| | Date 2-22.88 |
|---|---|
| NAME OF PROPOSED DEVELOPMENT Both | lo Crack Shopping Village, No 2 |

Notes on Whittle Garden Center

Whittle Development has submitted a request to amend PD-9 to add a garden center as a listed use, to approve a CUP for a garden center, and to approve a site plan/preliminary plat. The underlying zoning in this area is General Retail and that classification does not include a garden center as a listed use. The Overlay District does allow a garden center with a CUP. The applicant is proposing a Calloway's type facility at this location, to be constructed in two phases. Our comments regarding this plan are as follows:

E. TEAL SURVEY ~ ABSTRACT NO. 207

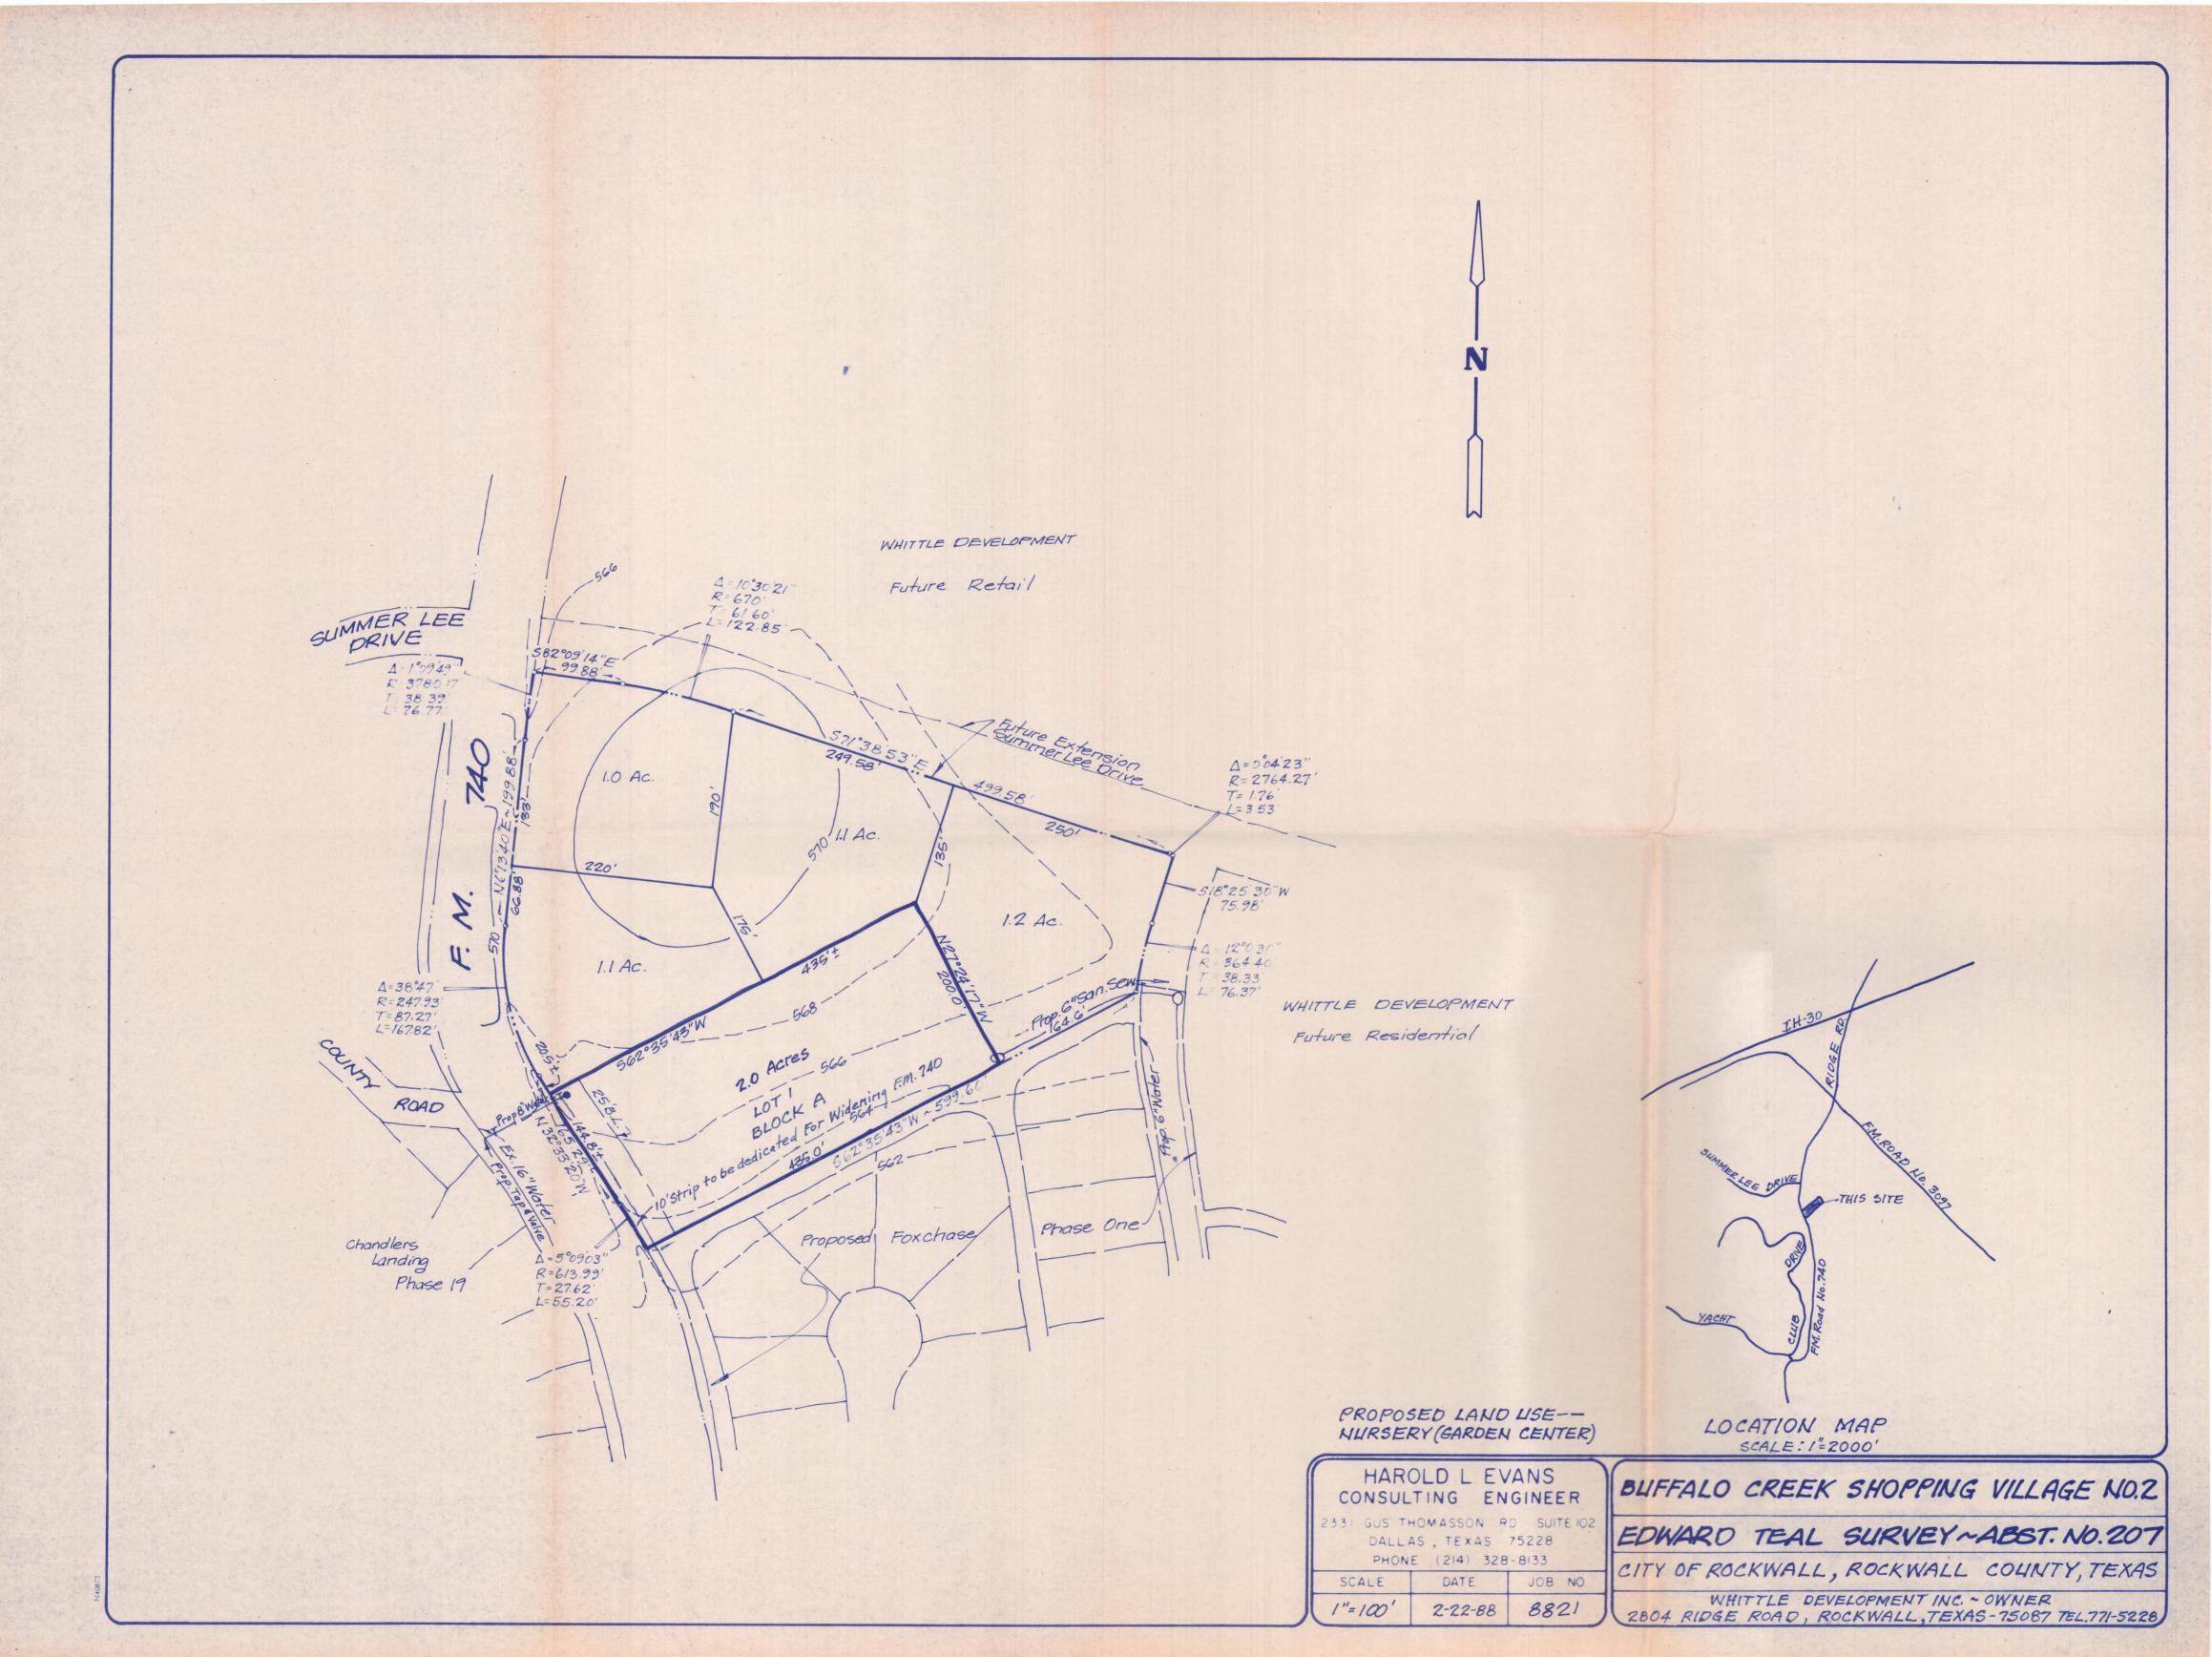
1. A determination needs to be made by the time of final plat as to what right-of-way might be needed to address the problem of the curve that exists on FM-740.

- b. Additional right-of-way dedication at the final plat stage to provide room for realignment of FM-740
- 3. A site plan subject to the following conditions:

STETAIL NURSERY 50: 1" = 30:0" CHAS. E. HODGES A. I.A LANDSCAPE HURSERT 214-771-0044 FM. 740 RIDGE RD. ROCKHALL, TEXAS 2233 KIDGE RD. ROCKWALL TX 75087 22 FEB . 1988

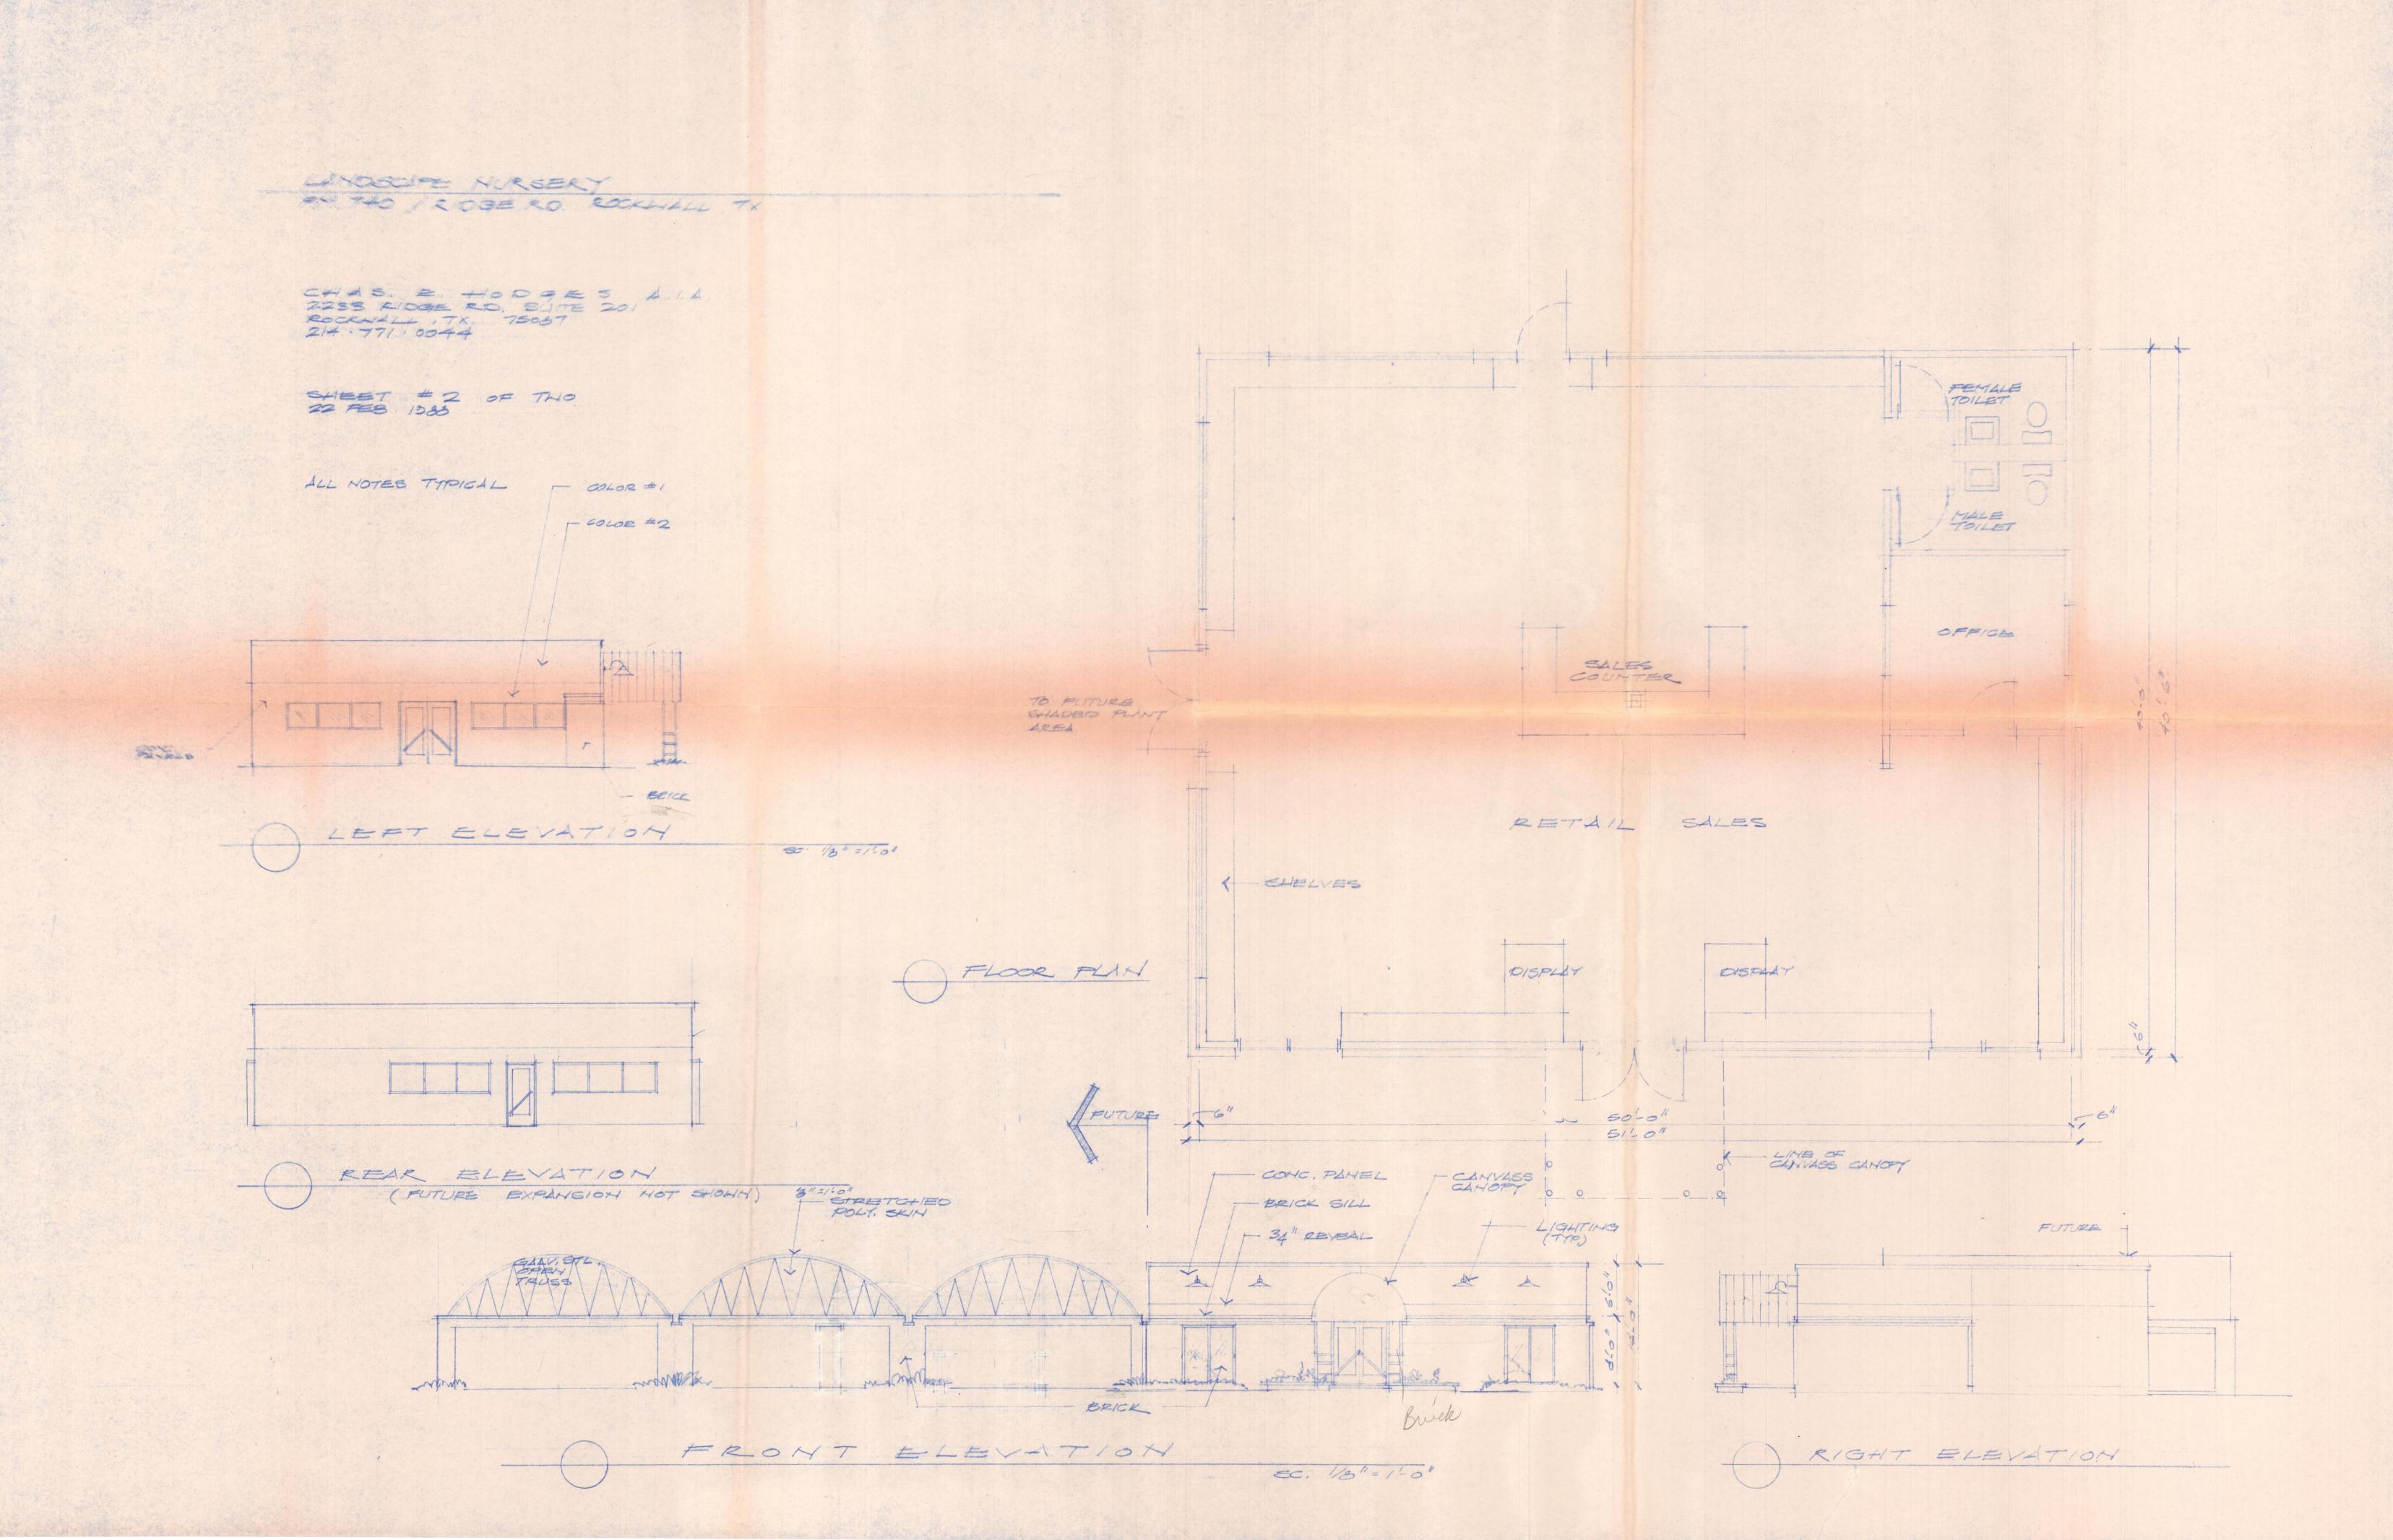
- 1. One major concern, as with the other sites in PD-9, was the lack of a Concept Plan for the entire area. We requested the developer to provide a Concept Plan and he has done so. A copy of the Concept Plan is included in the packet.
- 2. Cross access easements need to be provided for connection with sites to the north.
- 3. All other technical concerns were addressed by the developer at the time P&Z reviewed the application.

- 1. That the use be approved provided that the structure is a permanent structure, that the screening is masonry, not wood, and that adequate right-of-way is provided on FM-740 to correct the alignment of FM-740.
- 2. That the front and sides be all brick.
- 3. That the fence be a 6 ft. concrete flat formed wall with a brick cap and 2 ft. brick pilasters every 30 ft. from face of building to rear property line.
- 4. That the entrance not exceed 30 ft. in width.
- 5. That the sales area/office have a hip or gable roof with minimum 6/12 pitch or a mansard roof a minimum of 8 ft. from the plate line; constructed of tile or metal standing seam.

- 1. One major concern, as with the other sites in PD-9, is that we don't have a Concept Plan for the entire area. We have requested the developer to provide a Concept Plan.
- 2. Cross access easements need to be provided for connection with sites to the north.
- 3. The building needs to be set back off of the side property line 30 feet, adjacent to the residential.
- 4. A timetable for completion of Phase 2 may be an item to discuss.
- 5. The dumpster screen needs to be of the same material as the main structure.
- 6. Under the Overlay District, the screening fence must be of masonry unless otherwise approved by P&Z and Council.
- 7. The brick used on this facility needs to blend with the brick used on $Mr.\ M.$

- an amendment to PD-9 to include a garden center as a listed use;
- a Conditional Use Permit for a garden center located on Ridge Road south of Summer Lea Drive;
- 3. a preliminary plat subject to:
 - provision of access easements for cross access to the north;
 - additional right-of-way dedication at the final palt stage to provide room for realignment of FM-740;
- 4. A site plan subject to the following conditions:
 - the building is a permanent structure
 - screening is masonry, not wood
 - c. front and sides are all brick
 - d. entrance not to exceed 30 feet in width
 - e. brick to be medium beige tone
 - forest green standing seam roof.
 - dumpster screen to be of the same materials as the main g.
 - any vehicle left on the site will be located behind the building in the area designated as concrete products sales area
 - cross access drive needs to be shown on the site plan

- i. Cross access drive needs to be shown on the site plan
 - k. That the fence be a 6 foot concrete flat formed wall with a brick cap and 2 foot brick pilasters every 30 feet from face of building to rear property line
